**Arboricultural Method Statement for
Approved Extension at
12 Keats Grove,
Hampstead,
London.
NW3 2RN**

This report has been prepared for a Section 73 application to amend the information submitted to discharge the tree protection issues required by condition 6 of planning permission 2019/5443/P dated 26/02/2020 (as amended by 2020/3584/P dated 26/11/20).

**Prepared by
Peter Wilkins BA(Hons) MArborA MEnvSc.
Our Ref 0221-9009
February 2021**

Drawing 1

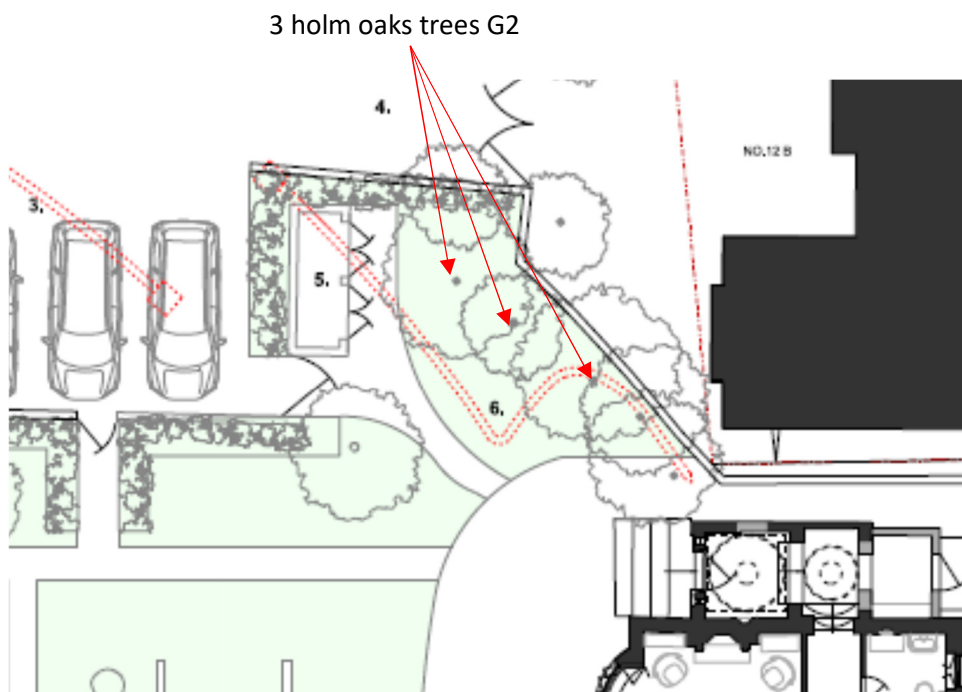
- 3.1 The trees are also shown in the approved plans for Plans for Planning Reference 2019/5443/P as retained in the correct location with the 1.2m high retaining wall to the front of the trees demolished. . See Drawing 1 below.

Scale	See Scale Bar	Drawn by
Date	22/02/2021	PW
Project No.	0221-9009	Checked by
Dwg. No.	TPP-01	JG

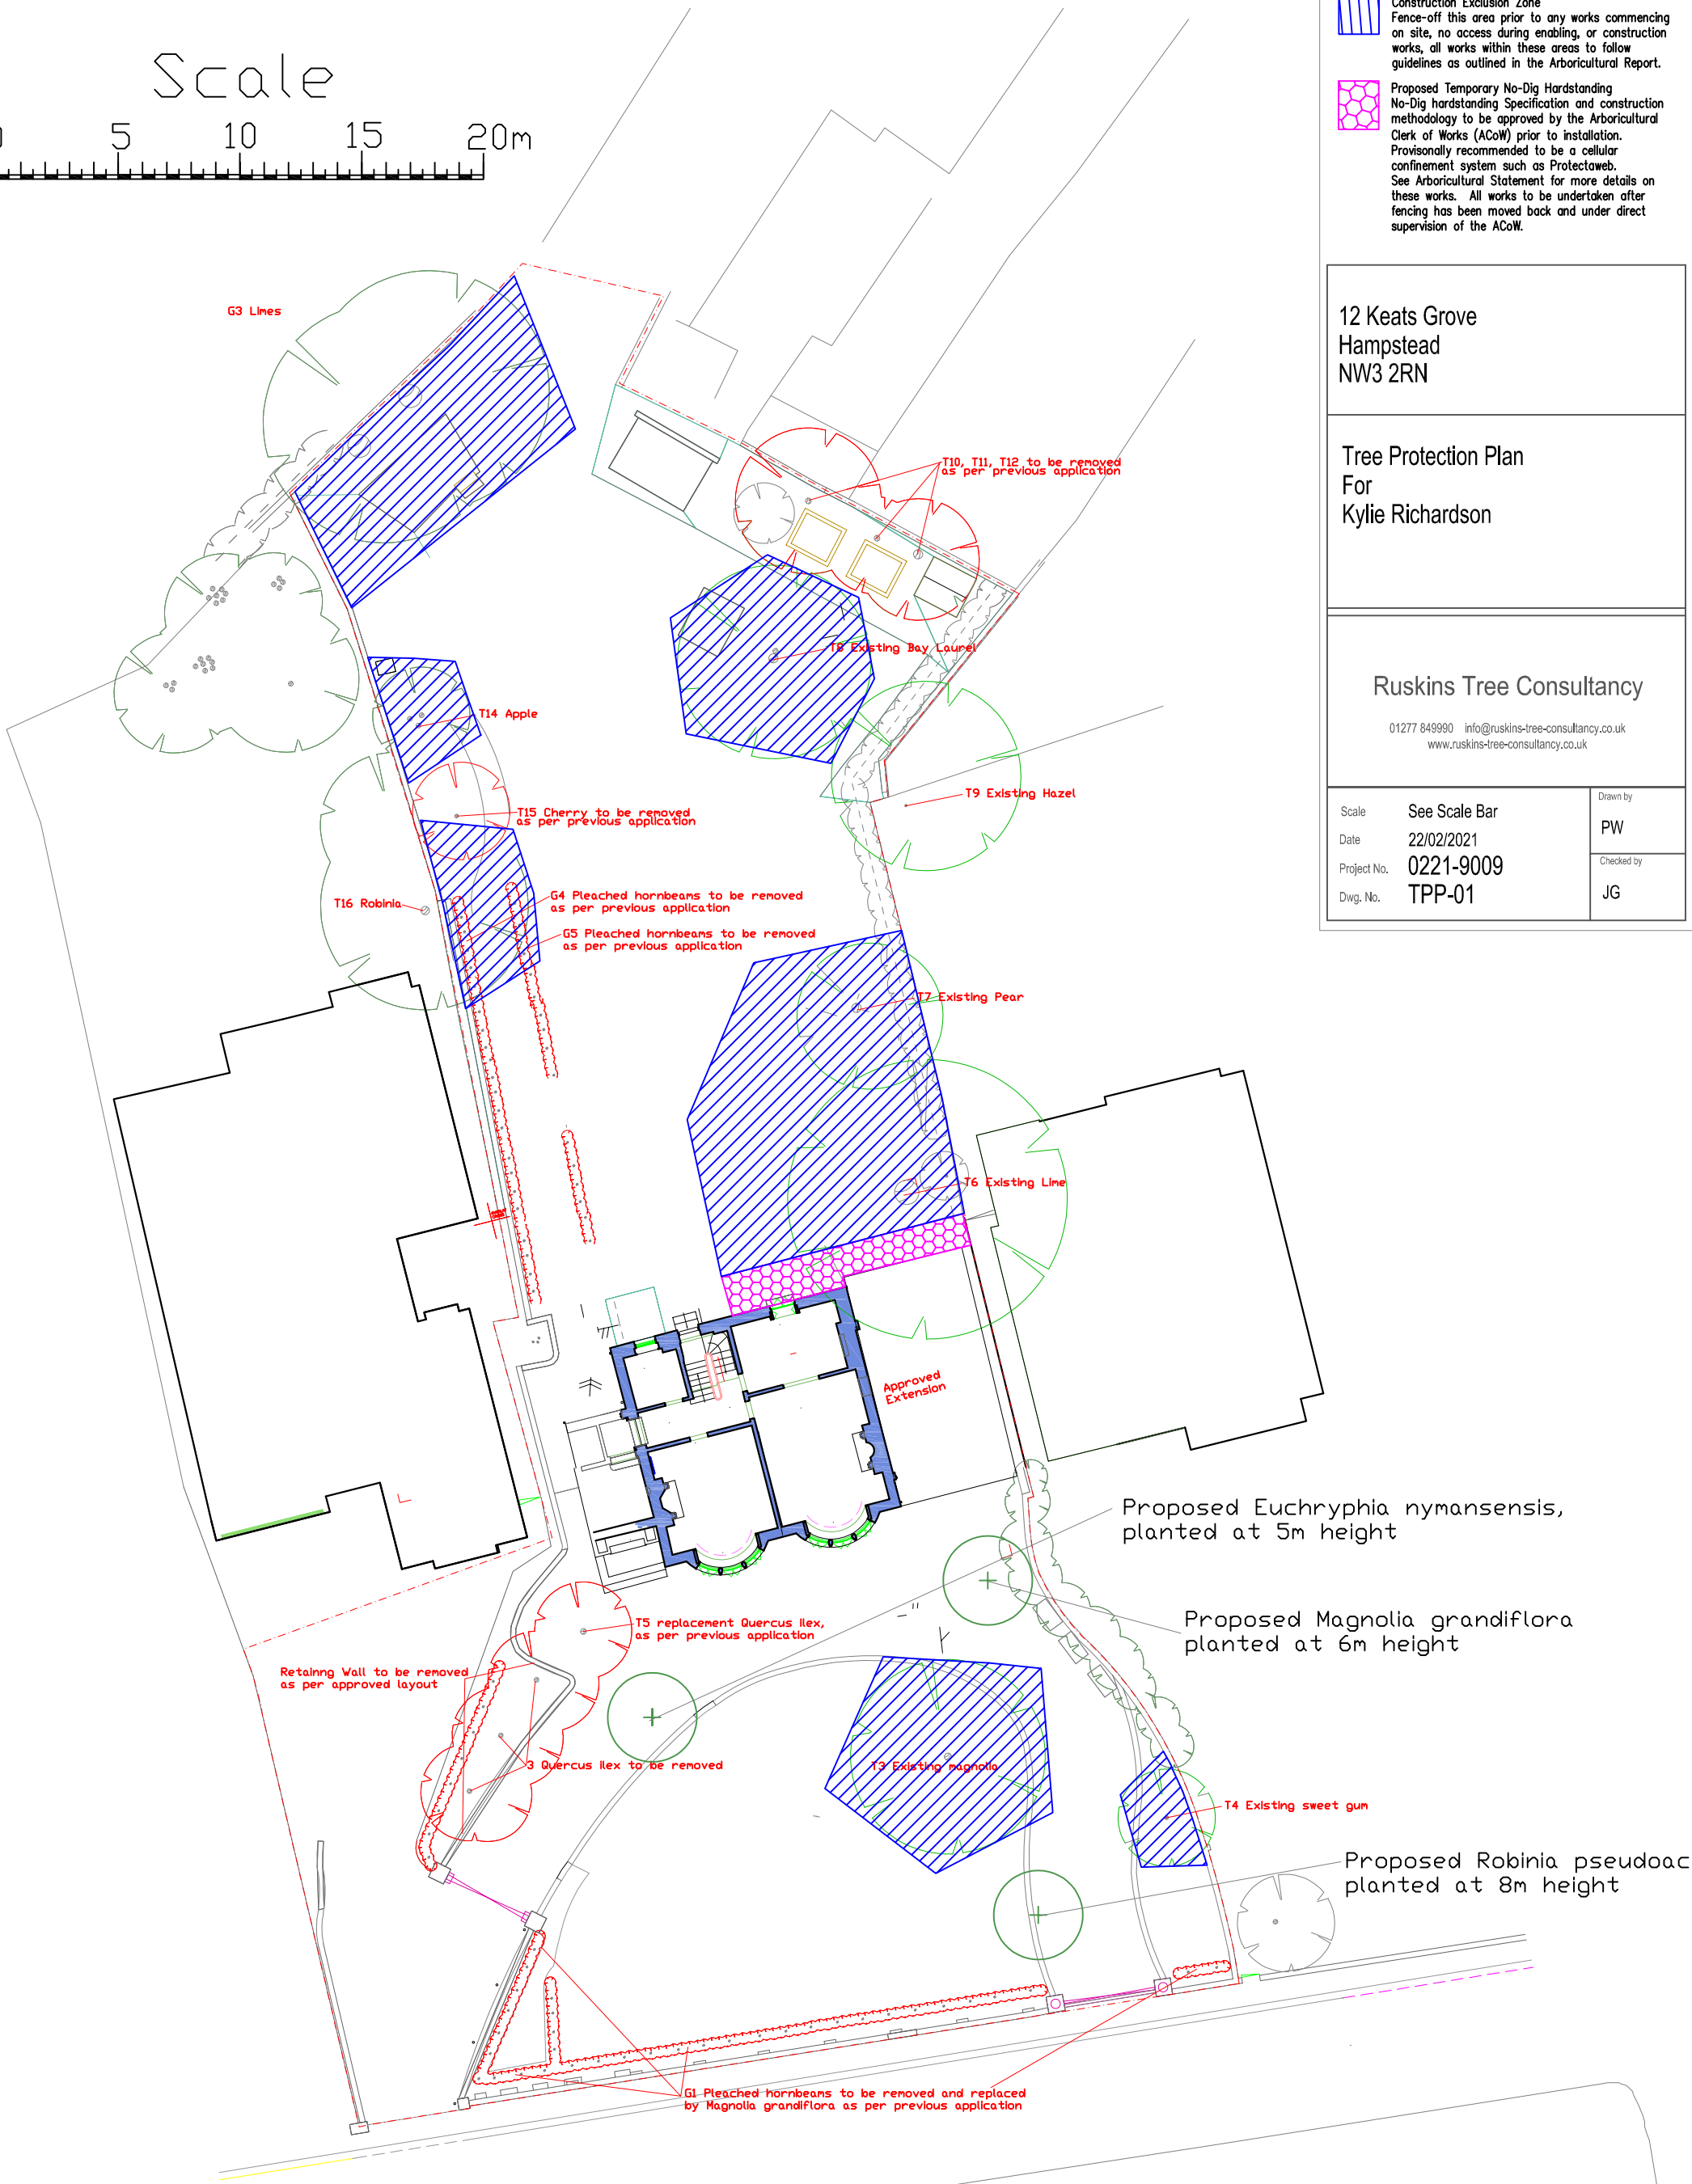
4.2 In addition to the trees listed above three Holm Oaks G2 are to be removed.

4.3 To allow for the implementation of the approved works, including demolition of the retaining wall, it is proposed to remove the 3 Holm oaks G2 and we have included a plan showing the trees to be planted a replacements for G2 which are listed below:

- 4.5 It should be noted that Condition 6 does not require submission of a landscaping plan.
- 4.6 We have provided a revised Tree Protection Plan showing the holm oaks G2 to be removed and to supersede the tree protection plan prepared by Andrew Day, see appendix 1 .

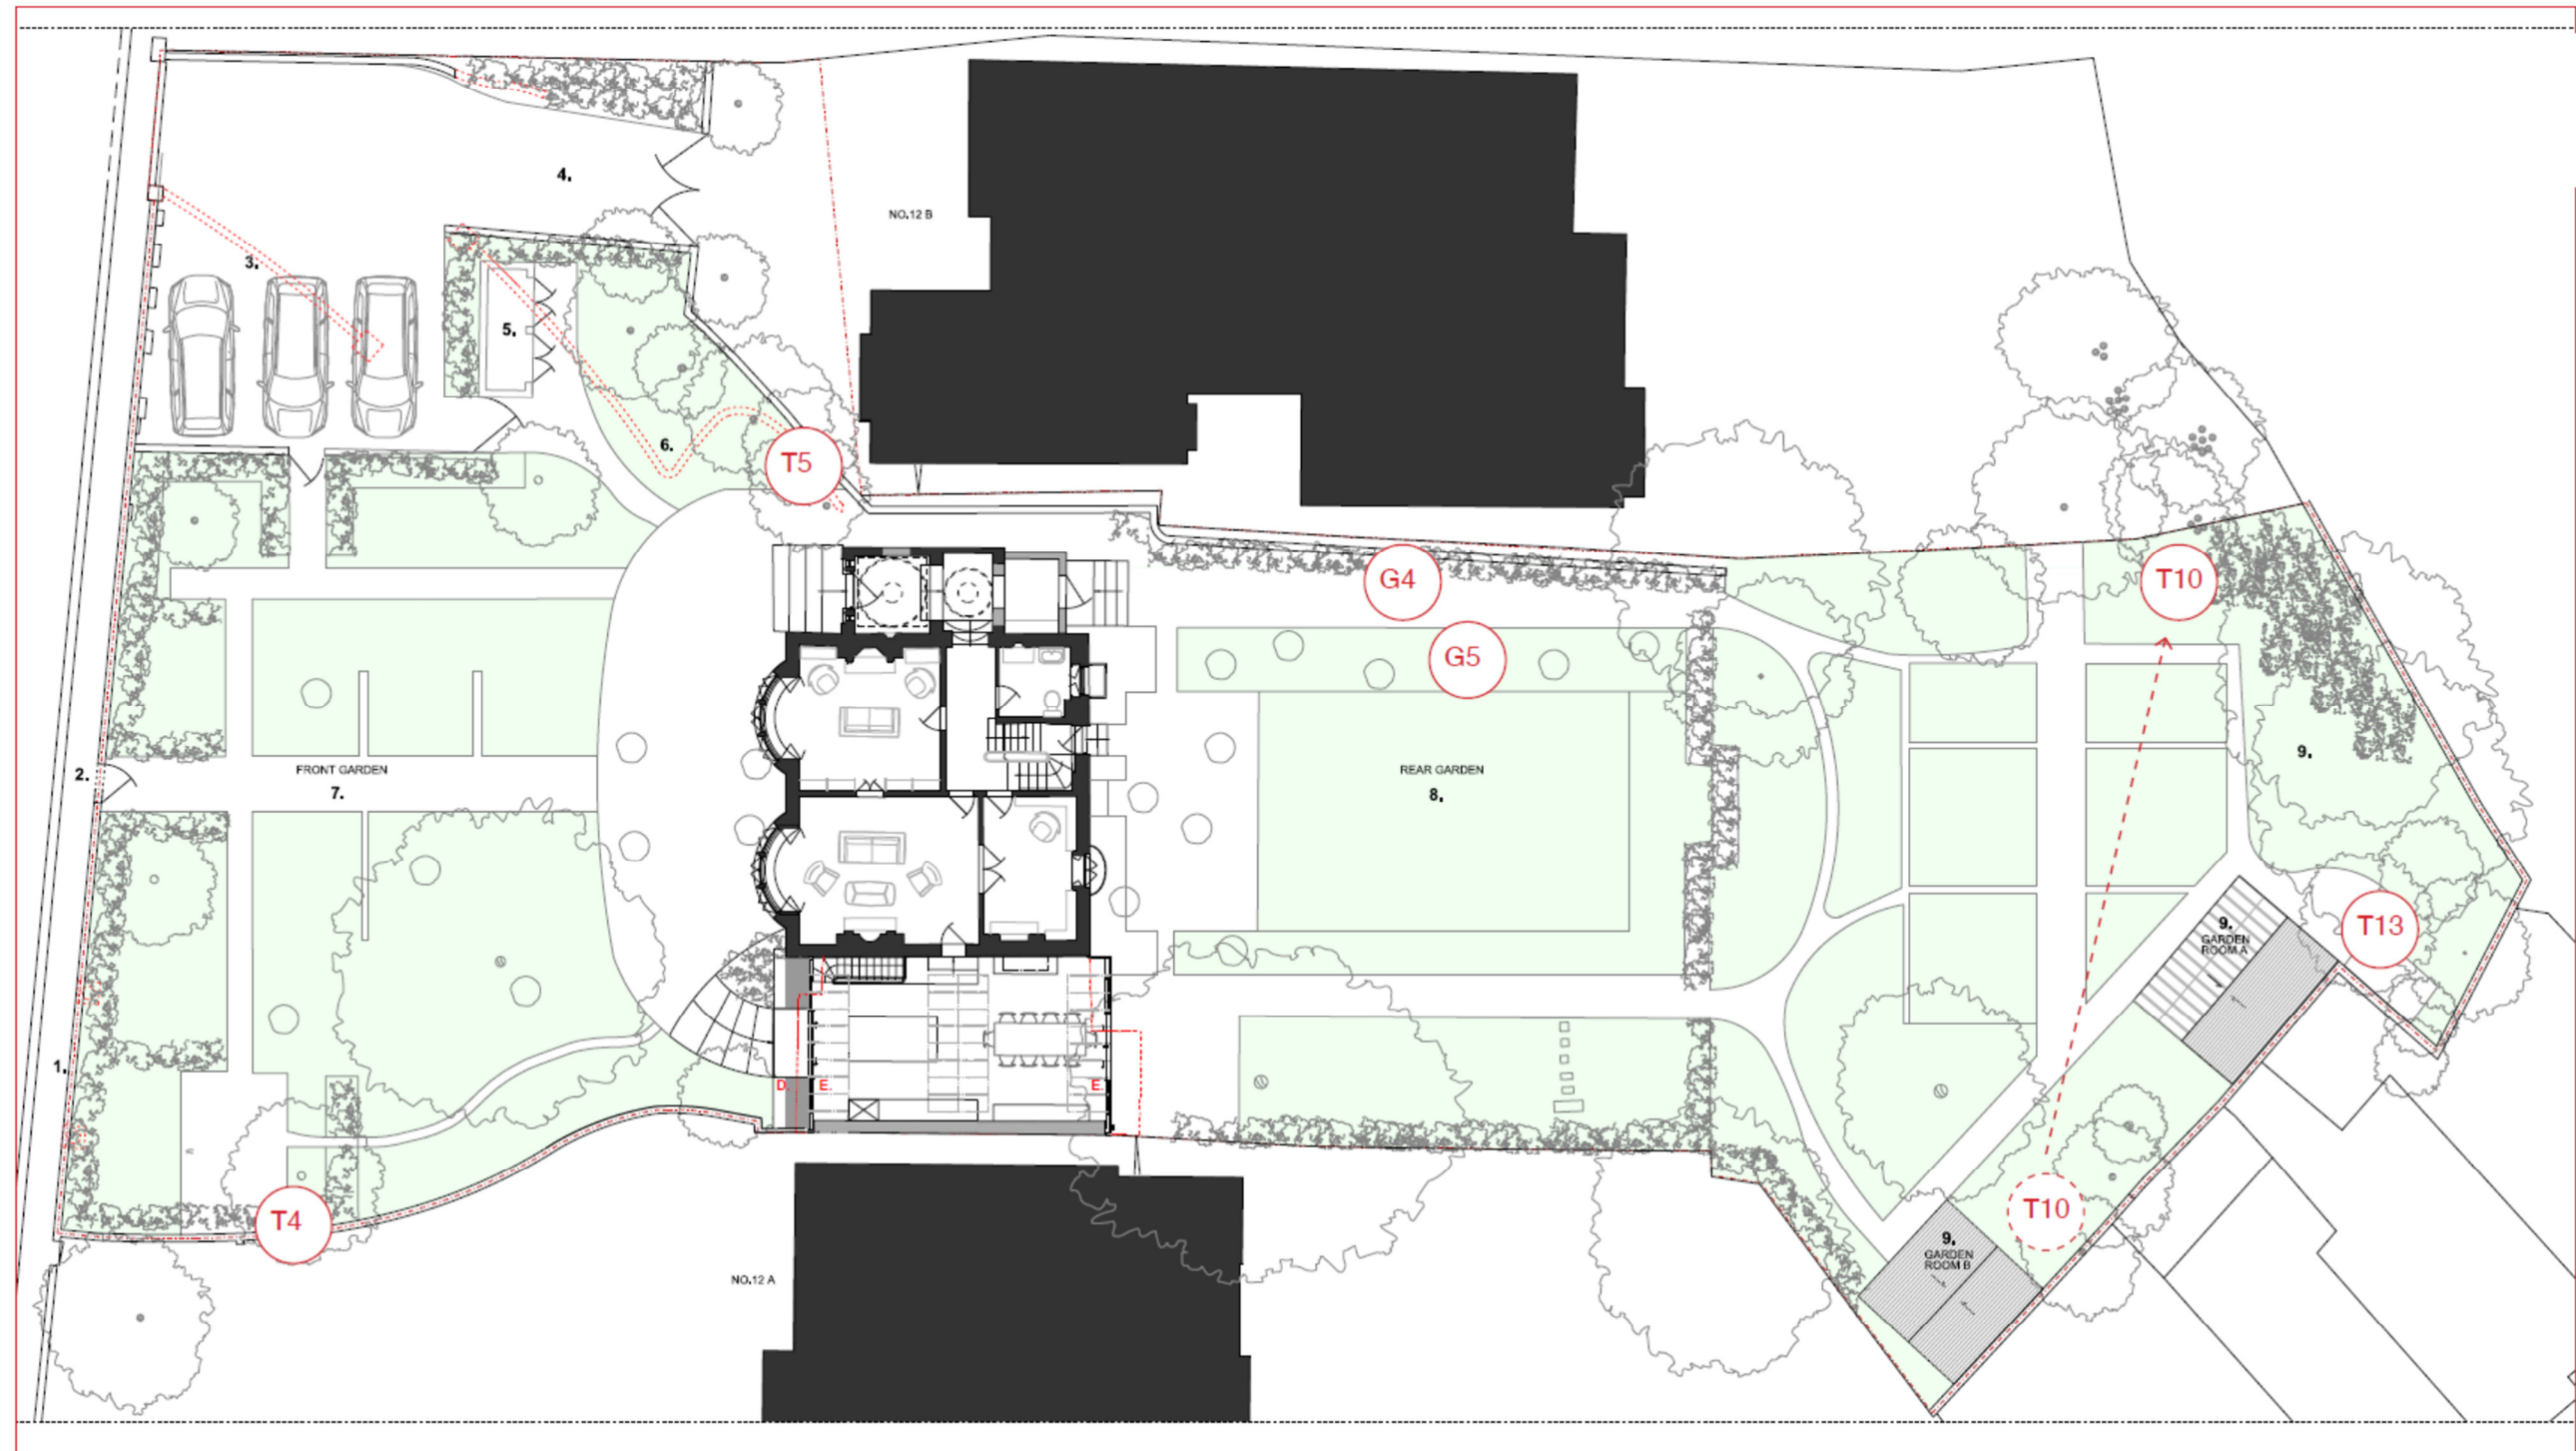
1.3 The Arboricultural report by Andrew Day was incorrect in that showed the 3 Holm oaks G2 as retained, it also stated they would be protected by the existing retaining wall. The retained wall was approved for removal and it is not physically possible to remove the wall, retain the trees and construct the approved wall and bin-store. In light of the errors we have spoken to Nick Bell the London Borough of Camden Tree Officer and have agreed that the best way forward We have therefore prepared a Tree Protection Plan and Arboricultural Method Statement for a Section 73 application to amend the information submitted to discharge the tree protection issues required by condition 6 of planning permission 2019/5443/P dated 26/02/2020 (as amended by 2020/3584/P dated 26/11/20).

3.3 Drawing 3 is an extract of the Tree Protection Plan from the Arboricultural Report dated 7th October 2019 prepared by Andrew Day with annotated notes & additions by Studio Dera 23.12.20 in red in response to planners email 21.12.20. . See Appendix 1 of this report for the full plan. This report was prepared to provide the details of tree protection required by condition 6 of planning permission 2019/5443/P dated 26/02/2020 (as amended by 2020/3584/P dated 26/11/20) showed the 3 Holm oaks G2 as retained, it also stated they would be protected by the existing wall which was approved for removal. See Appendix 1 of this report
